ROADWAY PLAN
STA. 9+00 TO STA. 14+00
INTERSTATE ROUTE H-1 REHABILITATION
Middle Street to Vicinity of Ward Avenue
FAP NO. IM-HI-1(269)

"AS-BUILT"

INTERSTATE ROUTE H-1 REHABILITATION
Middle Street to Vicinity of Ward Avenue
FAP NO. 1M-HI-1(269)

ROADWAY PLAN
STA. 124+00 TO STA. 134+00
INTERSTATE ROUTE H-1 REHABILITATION
Middle Street to Vicinity of Ward Avenue
FAP NO. 1M-HI-1(269)

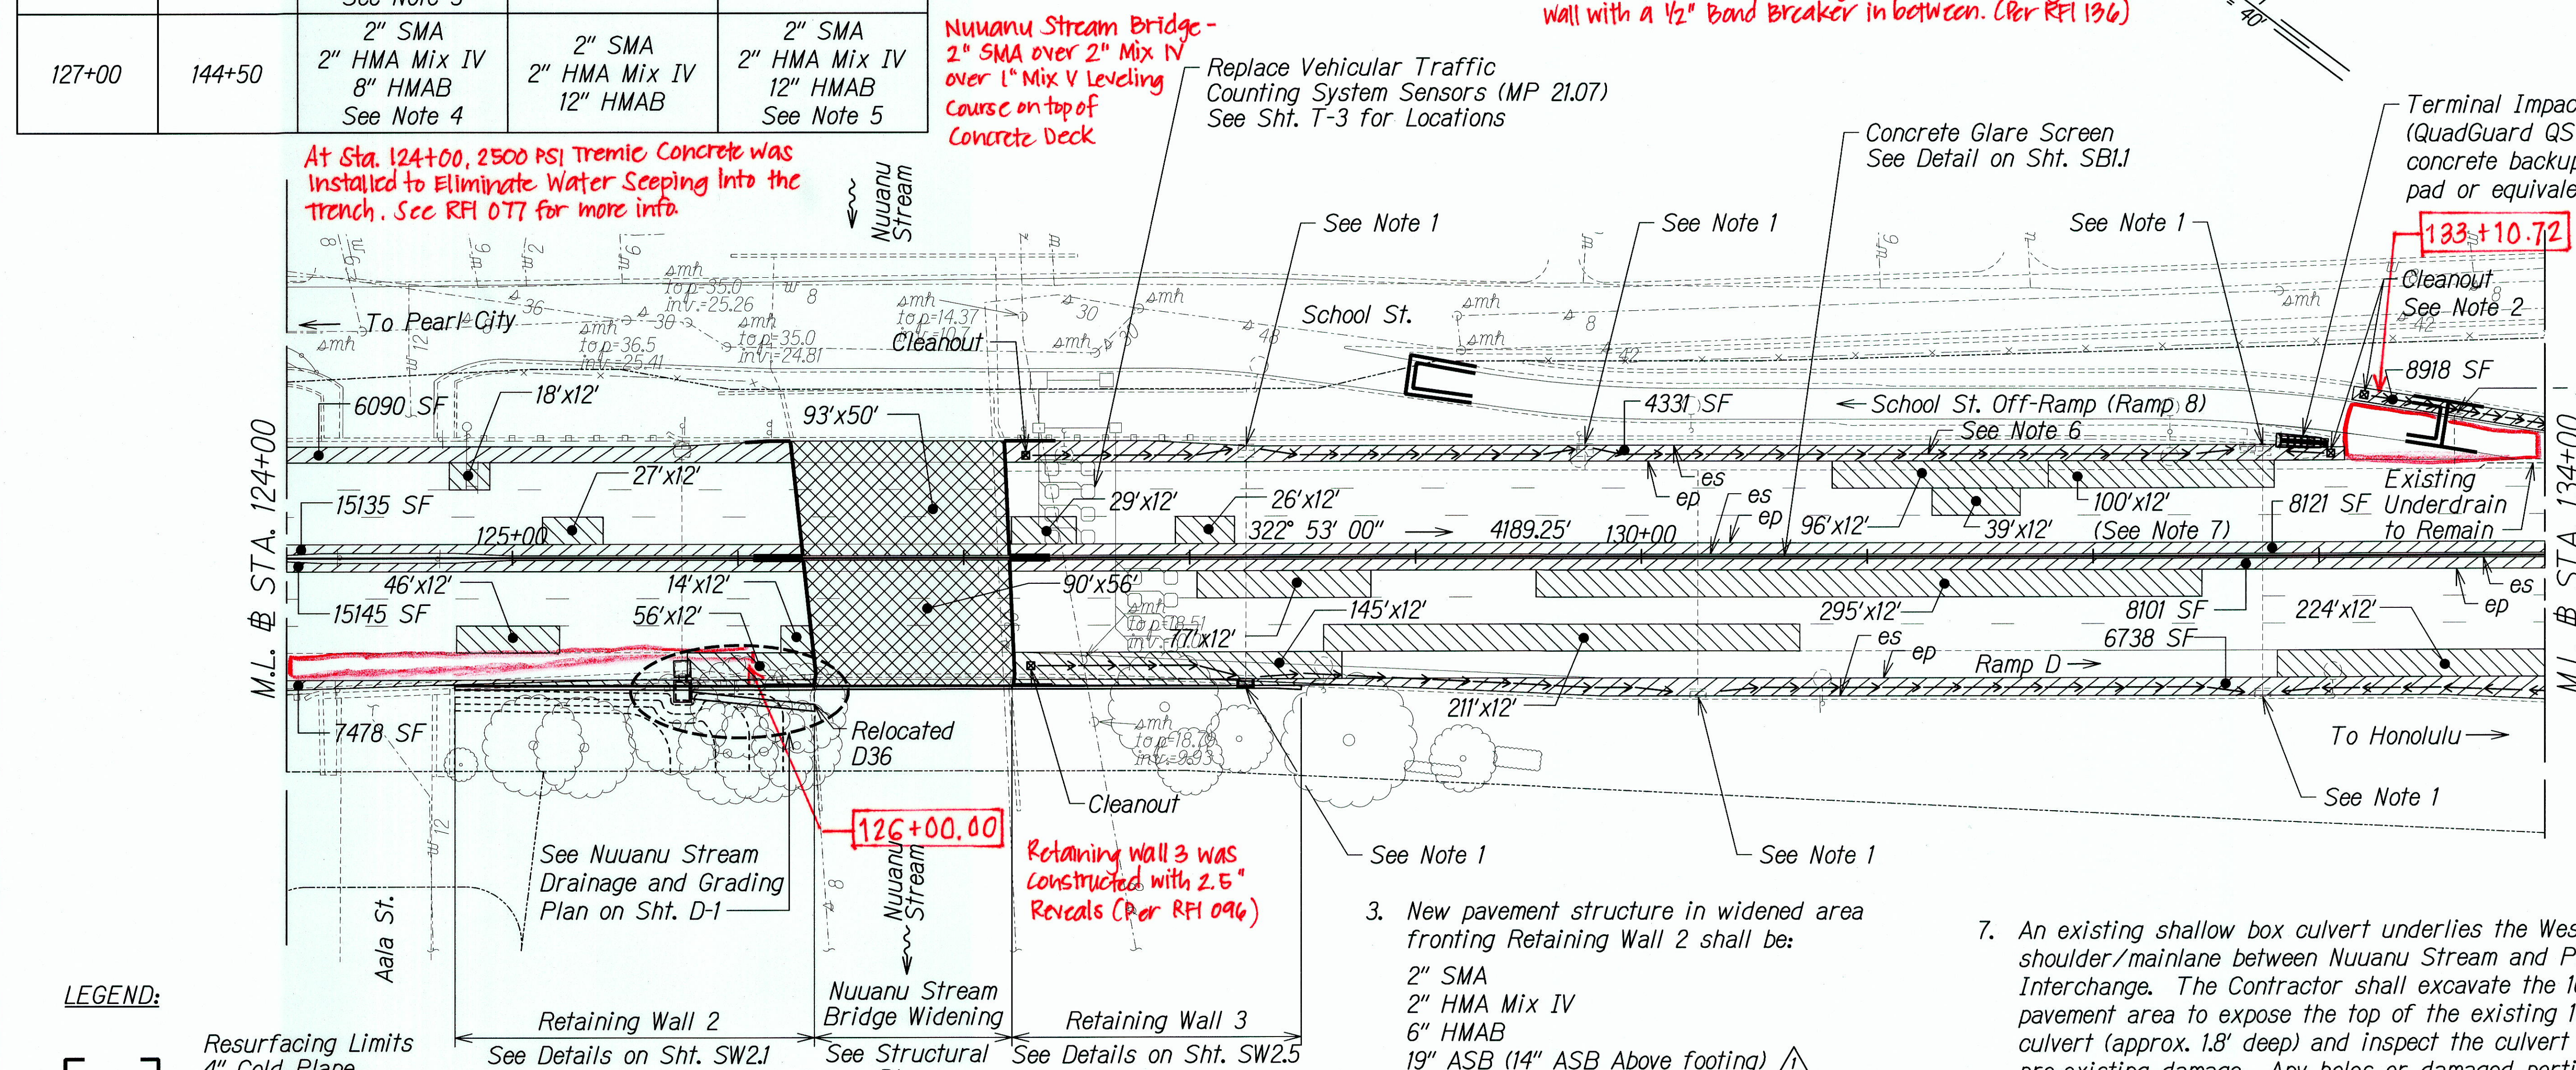
At the School St. Off-Ramp, the Existing Concrete Pad (Not shown on the plans) was removed to install New Impact Attenuator. The New Attenuator Concrete Pad was installed against the Retaining Wall with a 1/2" Band Breaker in between. (Per RFI 136)

Nuuanu Stream Bridge - 2" SMA over 2" Mix IV over 1" Mix V Leveling Course on top of Concrete Deck

At Sta. 124+00, 2500 PSI Tremie Concrete was Installed to Eliminate Water Seeping into the Trench. See RFI 077 for more info.
